Planning Commission Staff Report

Consideration of a Preliminary Plat application for the Roundy Estates Plat “A” subdivision consisting of one lot located at approximately 2200 East Maple Canyon Road in the Critical Environmental (CE-1) Zone.

ROUNDY ESTATES PLAT "A"
M & D ROUNDY BROTHERS, LLC
PLAN & PROFILE - MAPLE CANYON

MAPLETON CITY DEVELOPMENT REVIEW COMMITTEE MINUTES

C3.4
OF SHEETS
Proj #

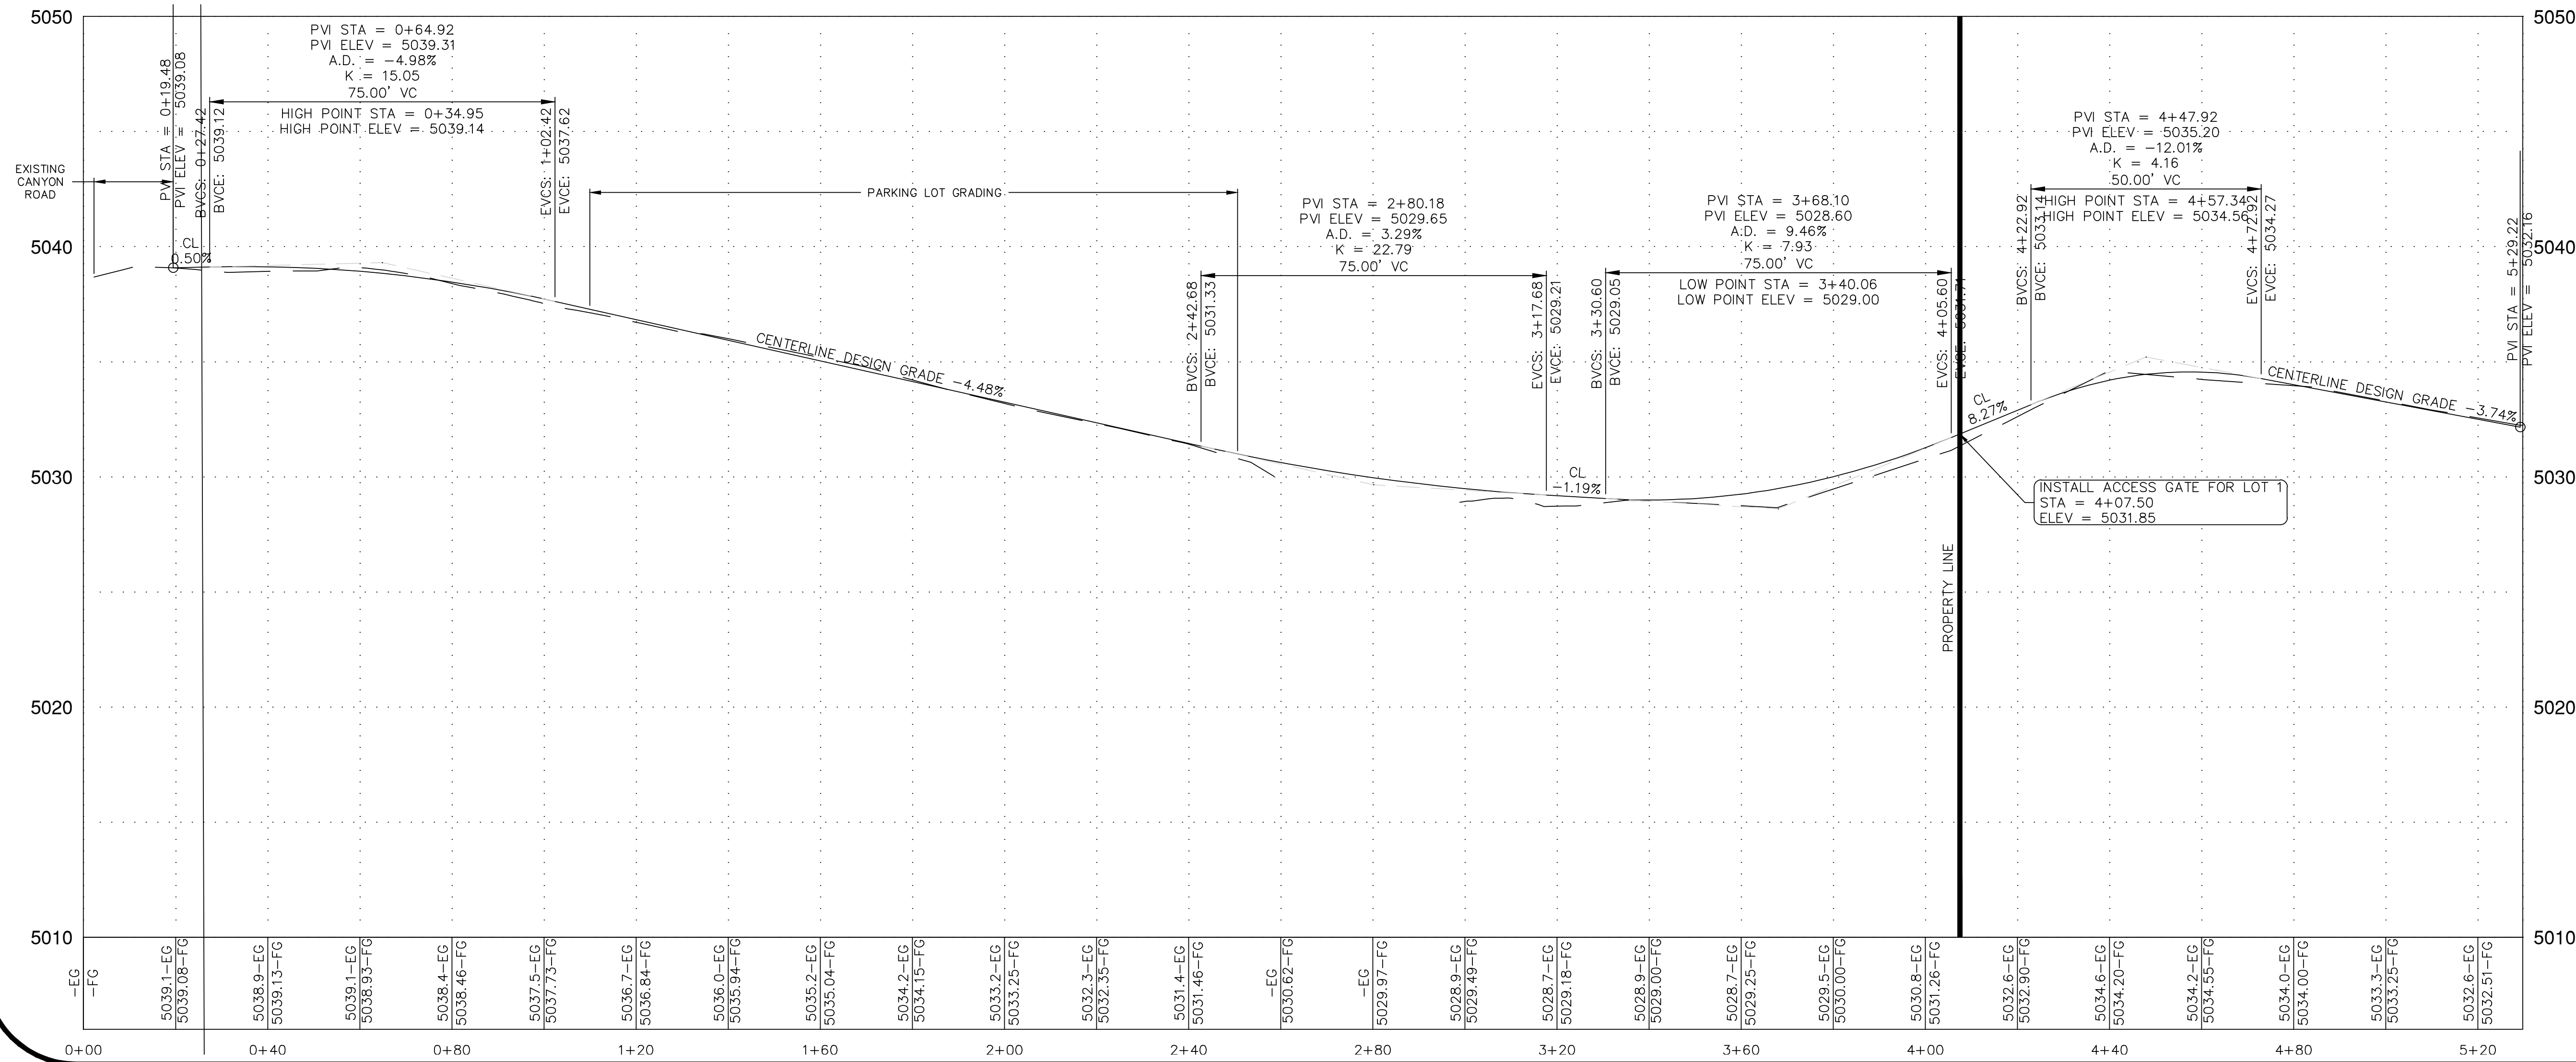
1. Please show connection to future Foothill Bench Waterline for culinary water, this connection cannot be a direct lateral.

C3.5
OF SHEETS

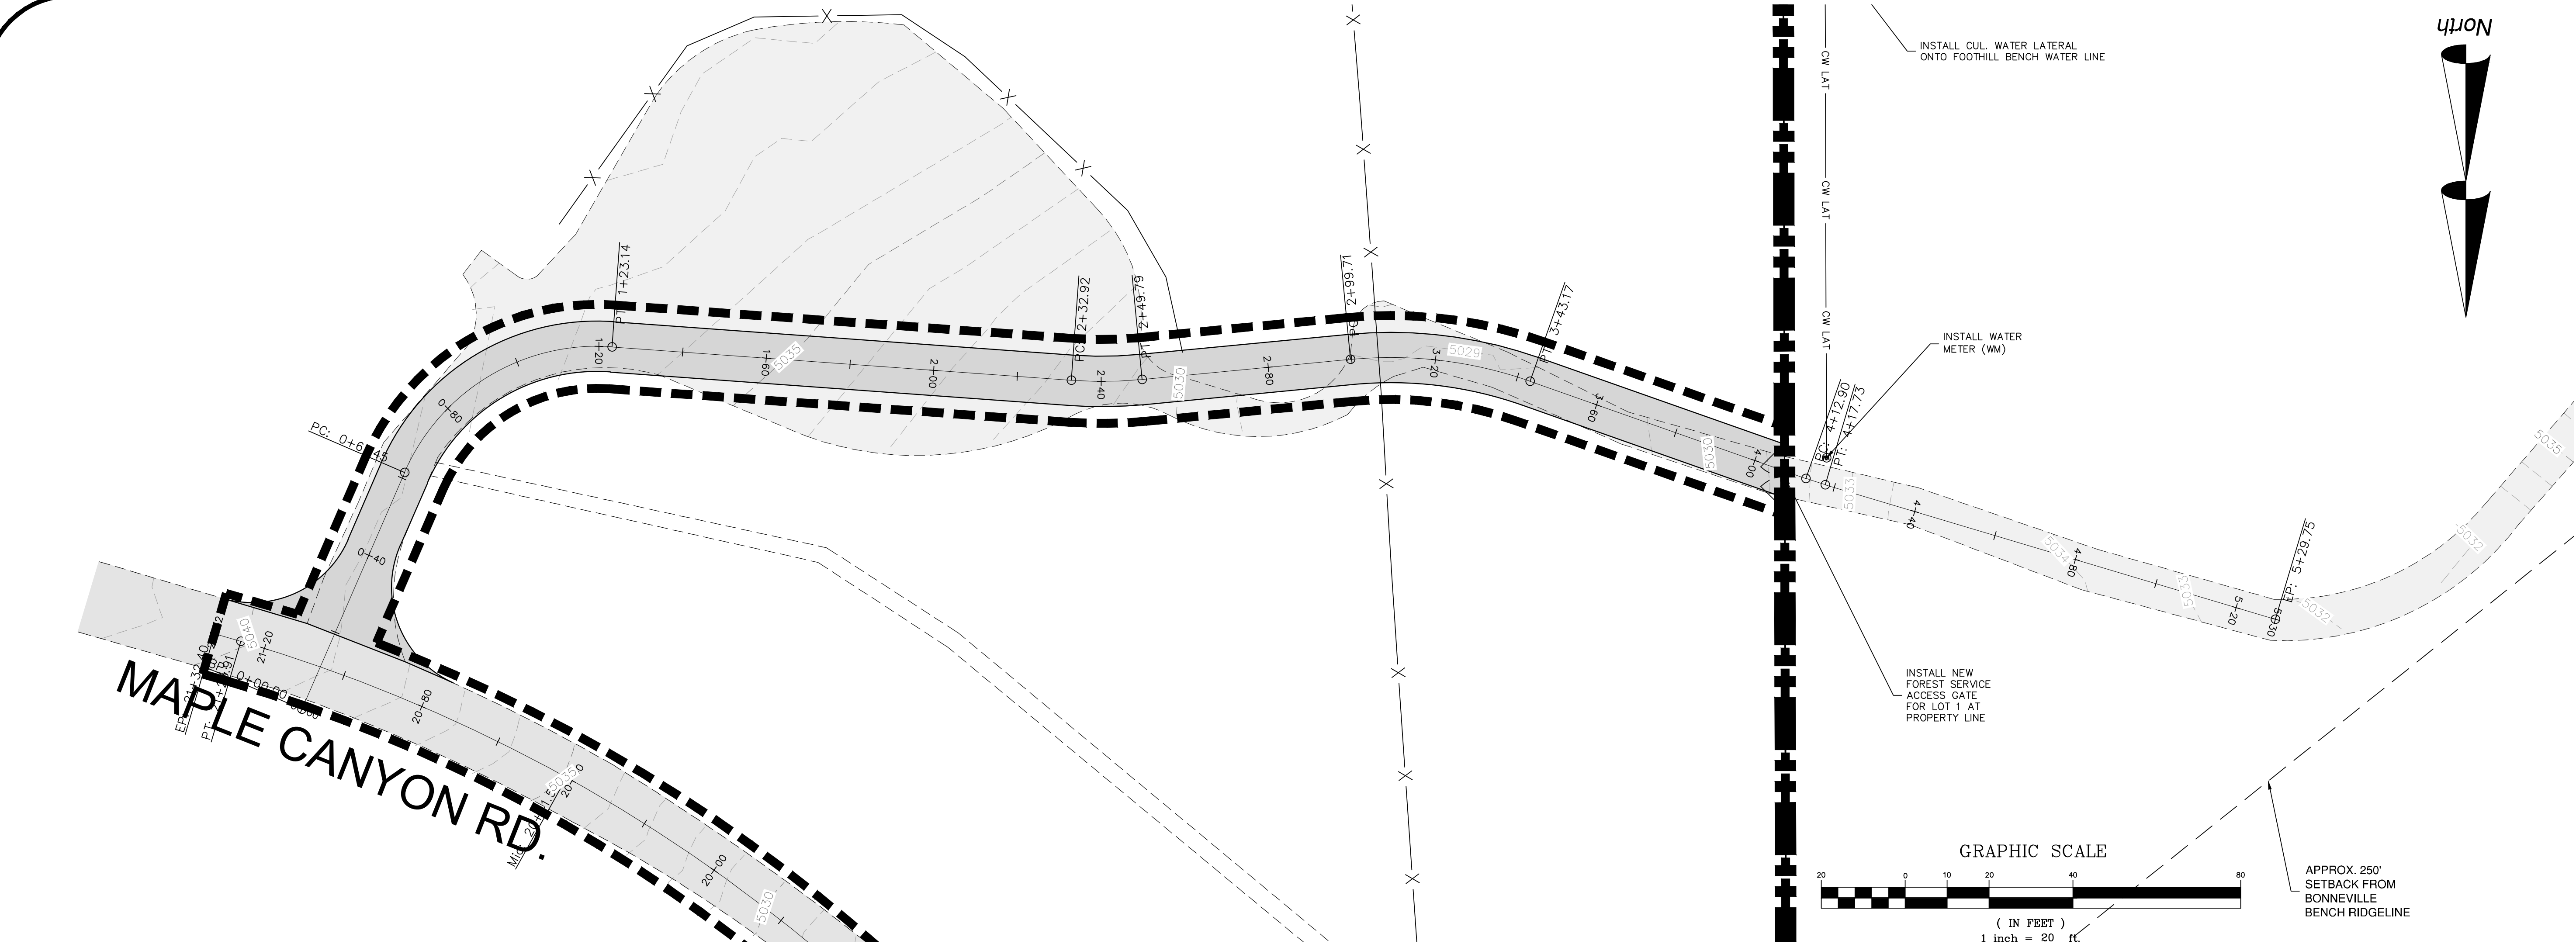
1. I apologize, I gave you the wrong address last time for lot 2. On the final mylar please have the address as 2204 E.
2. Please indicate how the new lot will be accessed (through Forest Service lot?).
